First Revision No. 103-NFPA 780-2020 [Global Input]

First Revision No. 16-NFPA 780-2020 [Global Input]

Figure 4.8.6.3 Flat or Gently Sloping Roof with a Curved Perimeter.

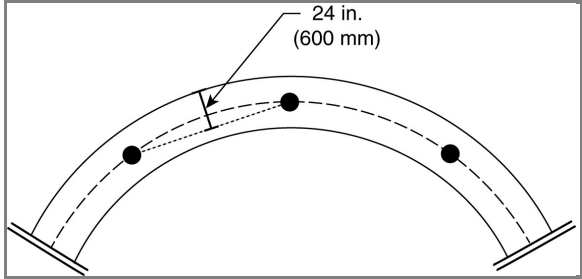
A curved perimeter of a structure shall be protected so that the outer edge of the structure is less than 24 in. (600 mm) from a straight line or chord between two adjacent air terminals, as shown in Figure 4.8.6.3, unless it is in a zone of protection in accordance with Section 4.8.

Committee Statement: The figure adds clarity to the existing requirement.
Response Message: FR-2-NFPA 780-2020
Public Input No. 205-NFPA 780-2020 [New Section after 4.7.6]

Figure 4.7.2.4(b) Lower Roof Protection Provided by Pitched-Roof Buildings 50 ft (15 m) or Less in Height.

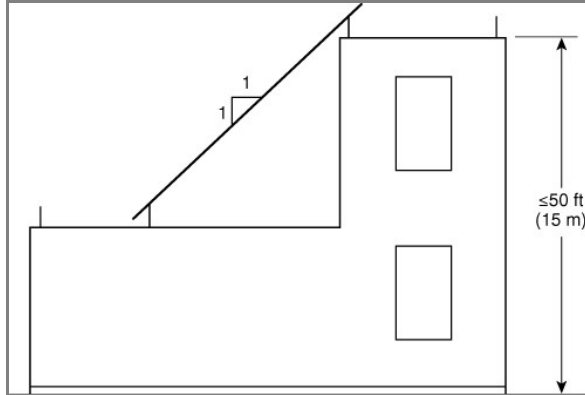
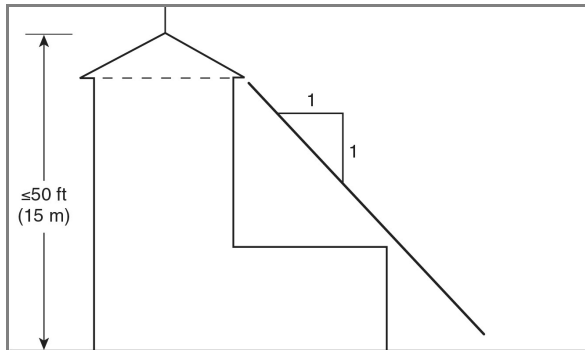
The purpose of Figure 4.7.2.4(b) is to provide a graphical representation of the area protected by the upper roof. The reference point is the eave because the criteria in 4.7.3 have been met and, thus, air terminals are not required on the ridge. It has been determined that this area is not susceptible to a direct strike.

Committee Statement: A greater explanation is necessary to understand that the protective angle is provided by the eave of the upper roof. A task group has been formed to clarify the protection of multilevel roofs. The text in 4.7.3 that indicates air terminals are not necessary on the eave of pitched roofs meeting the criteria of 4.7.3. The direct tie in 4.8.2.4 between the protective angle and multiple level roofs could be seen to exclude the applicability of the requirements of 4.7.3 when dealing with pitched roofs on the upper level of a multiple roof structure. Restructuring of Section 4.8 may be necessary to address the applicability of more than one of the methods identified in 4.8.1 used to determine the zone of protection for a structure.

Figure 8.3.3.5.2 Connection of Metallic Masts to Ground Ring Electrode.

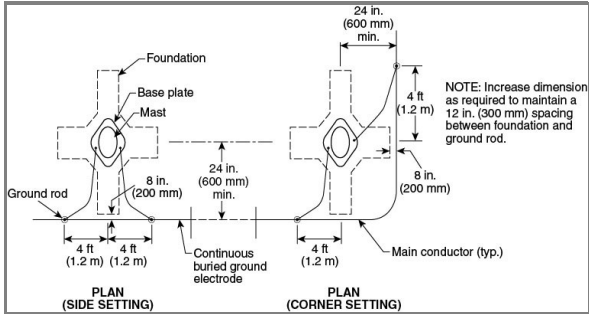
Metallic masts shall be grounded as shown in Figure 8.3.3.5.2.

Committee Statement: Annex material added to increase the explanation of ground ring conductors and the improvements they make to the overall LPS,
Response Message: FR-32-NFPA 780-2020
Public Input No. 194-NFPA 780-2020 [Section No. 8.3.3.5]
Public Input No. 193-NFPA 780-2020 [New Section after A.8.3.5]

Figure A.11.1.1(b) Isolation Method for Elevated Edge Lights Installed in Turf or Stabilized Soil.

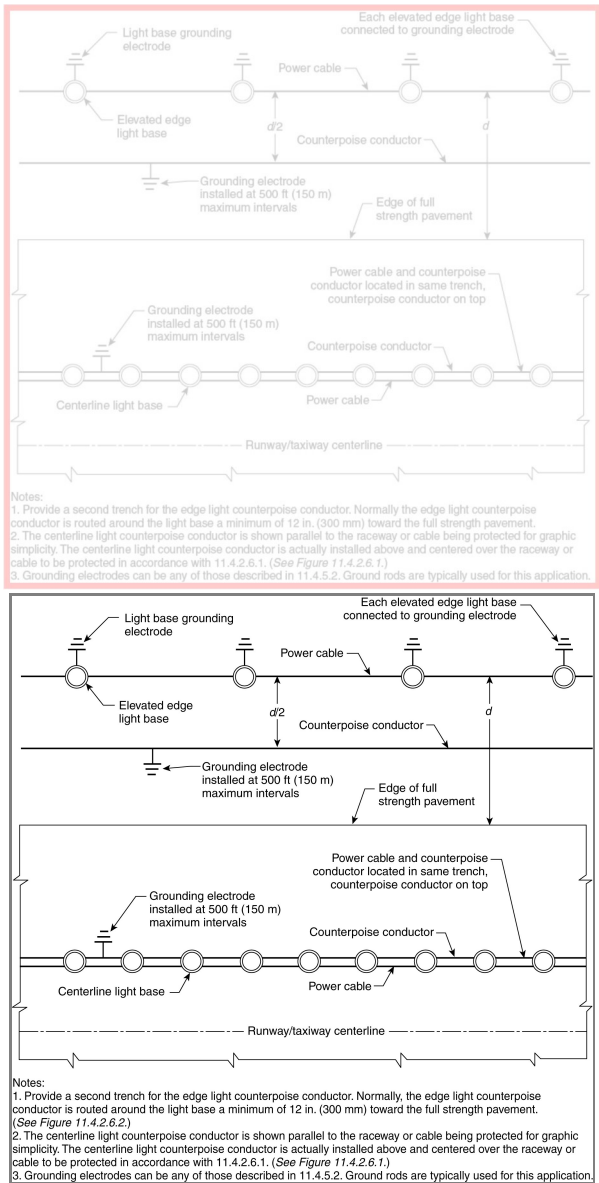
Committee Statement: Adding the reference to Figure 11.4.2.6.2 at the end of Note 1 in Figure A.11.1.1(b) corresponds with a similar reference in Figure A.11.1.1(a). Figure 11.4.2.6.2 provides an elevation view of the concept shown in the Figure A.11.1.1(b) plan view.

Figure E.1.3 Measurement of Ground Resistance.

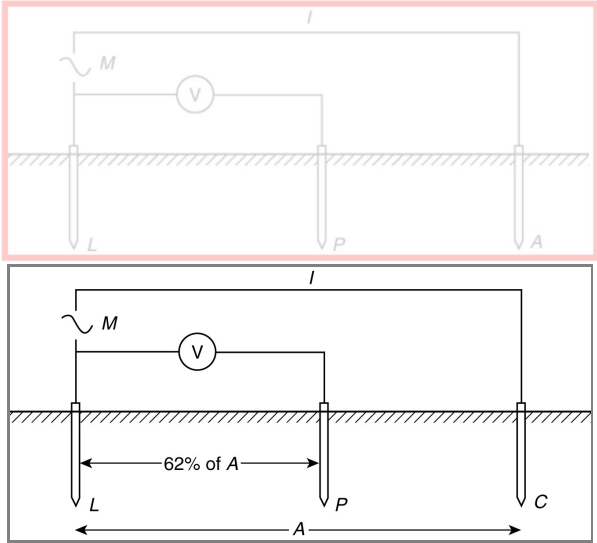
The principle of ground resistance measurement is shown in Figure E.1.3. *L* is the lightning ground-rod or ground-rod grounding electrode or grounding electrode system, *P* is a the potential (voltage) test probe, and *A C* is an auxiliary the remote current probe. *M* is the standard ac- earth resistivity measuring equipment for three-point technique ground resistance measurements. Convenient distances for *LP* and *LA LC* are 75 ft (23 m) and 120 ft (36 m), respectively. In general, *P* should be at 62 percent of the distance from *L* to *A C*. If a distance of 120 ft (36 m) is not convenient, it could can be increased significantly [or reduced to no less than 50 ft (15 m)], provided *LP* is increased/decreased proportionately.

Committee Statement:	The revised text clarifies the ground resistance test and coordinates test methodology with other standards, notably IEEE 81 (IEEE Guide for Measuring Earth Resistivity, Ground Impedance) and Earth Surface Potentials of a Grounding System.
Response Message:	FR-63-NFPA 780-2020

Figure F.1 Protection for Trees.

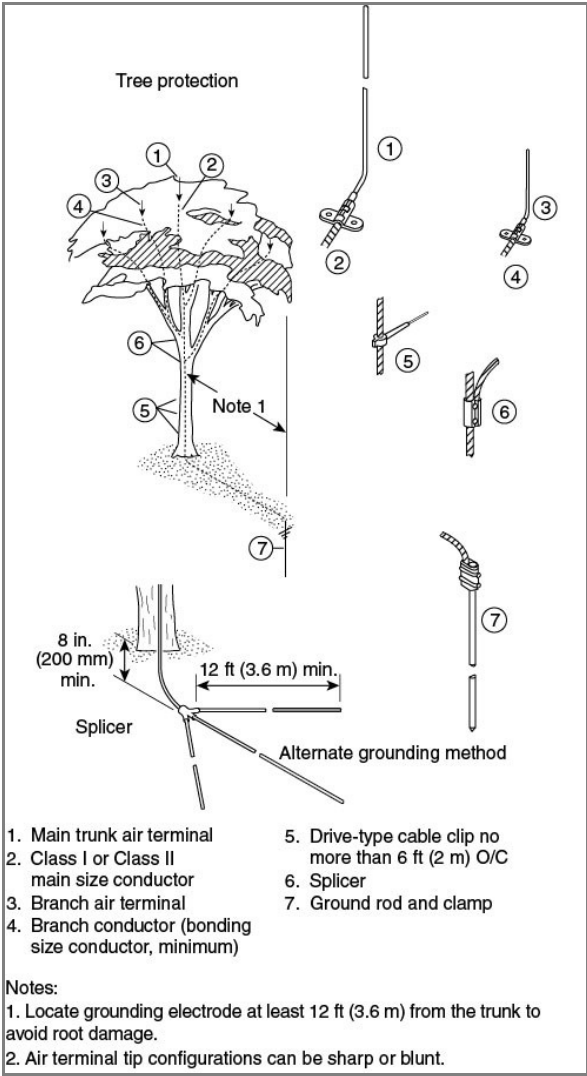
Note that it should not be inferred that adding protection to a tree will not ensure the safety of people seeking shelter under the tree during a thunderstorm. Possible sideflashes, step potential, and touch potentials could threaten the safety of people seeking shelter under trees, even if the trees are protected.

Committee Statement: The revision clarifies that protection of a tree will not ensure the safety of people seeking shelter under the tree during a thunderstorm. The purpose of the lightning protection systems is only to protect the tree from damage.
Response Message: FR-58-NFPA 780-2020

Figure J.5 Concept of Lightning Protection Zones. (Based on IEC 62305-4, Protection Against Lightning — Part 4: Electrical and Electronic Systems within Structures, Edition 2.)

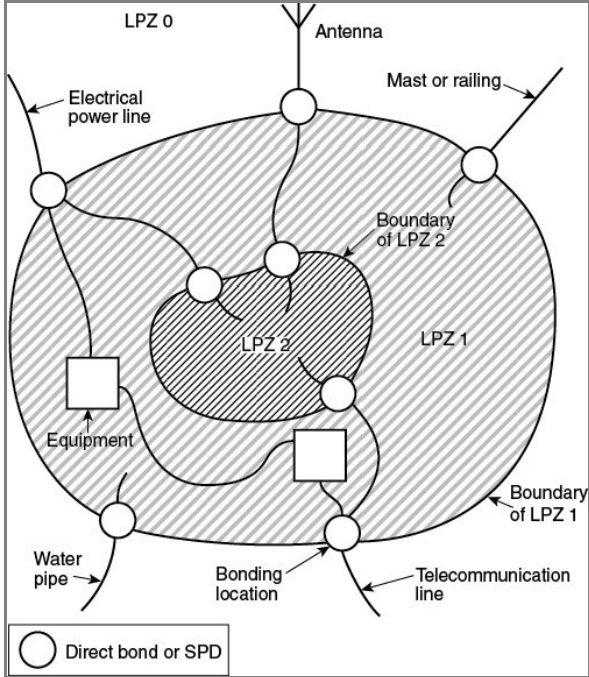
Direct bond or SPD surge protection zones interior to the structure are characterized by exposure to surge current levels limited by current sharing, isolating interfaces, and/or ~~by SPDs surge protection~~ at the boundary of the zone. The walls of the structure will likely attenuate the lightning electromagnetic field; , the amount of which will be dependent on the actual construction techniques. The initial lightning protection zone in a structure is indicated as LPZ 1 and the specific environment required for the zone is dictated by the characteristics of the internal electrical equipment (where the LEMP severity is compatible with the withstand level of the internal systems enclosed). Where there is electrical equipment with greater sensitivity to the LEMP environment defined for LPZ 1, successive zones should be established. The boundary of an LPZ is defined by the protection measures employed. Figure J.5 provides the general application of the zone concept and identifies an application with two internal zones. Subsequent zones reflect the need for greater limitations of surge current, which can be implemented through additional current sharing, isolating interfaces, and/or ~~and by~~ additional SPDs ~~surge protection~~ at the boundary. Additional spatial shielding should be used to further attenuate the lightning electromagnetic field.

Committee Statement: This revision corrects the terminology used to align J.5 with Section 4.20.
Response Message: FR-60-NFPA 780-2020
Public Input No. 117-NFPA 780-2020 [Section No. J.5]
